NEWBERRY SUBDIVISION

APPLICATION NUMBER 5 DATE July 15, 2021

REQUEST Subdivision

DETAIL SITE PLAN

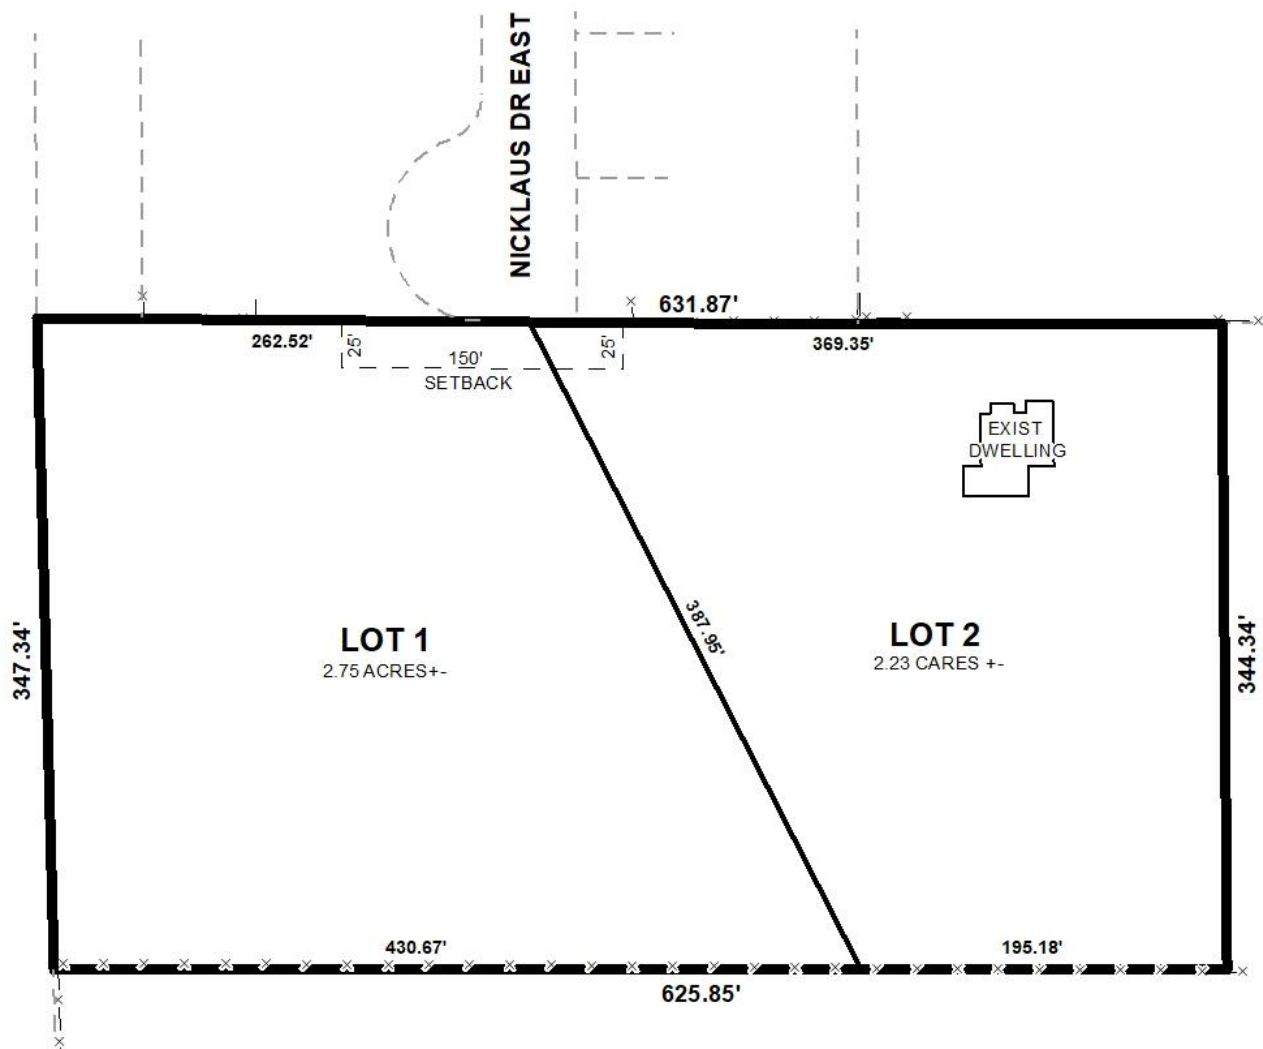
- A. Provide all of the required information on the SUBDIVISION PLAT (i.e. signature blocks, signatures, certification statements, written legal description, required notes, legend, scale, bearings and distances) that is required by the current Alabama State Board of Licensure for Professional Engineers and Land Surveyors.

- B. Show/label the Common Area listed in the legal description.
- C. Provide a graphic scale.
- D. Provide and label the monument set or found at each subdivision corner.

- E. Add a signature block for the Owner, Notary Public, Planning Commission, Traffic Engineer, and City Engineer.
- F. Provide the Surveyor's Certificate.

- G. Provide the Surveyor's and Owner's (notarized) signatures.
- H. Add a note to the SUBDIVISION PLAT stating that as shown on the 1984 aerial photo (FLIGHT 18 - #66) LOTS 1 and 2 will receive historical credit of existing (1984) impervious area towards stormwater detention requirement per Mobile City Code, Chapter 17, Storm Water Management and Flood Control) as follows: LOT 1 – NONE, LOT 2 – 3800 sf.

The subject site is located at the South terminus of Nicklaus Drive East, and has 50 feet of frontage on that street. The preliminary plat indicates that each of the proposed lots will have 25 feet of frontage on that street. If approved, as on the preliminary plat, the 25-foot minimum building setback should be retained on the Final Plat as blocked-out from the South terminus of Nicklaus Drive East. The proposed lots meet the minimum size requirements of the Subdivision Regulations. As on the preliminary plat, the lot size labels in both square feet and acres should be retained on the Final Plat, or a table should be furnished on the Final Plat providing the same information.

- 1) retention of the 25-foot minimum building setback line on the Final Plat as blocked-out from the South terminus of Nicklaus Drive East;
- 2) retention of the lot size labels in both square feet and acres on the Final Plat, or the furnishing of a table on the Final Plat providing the same information;
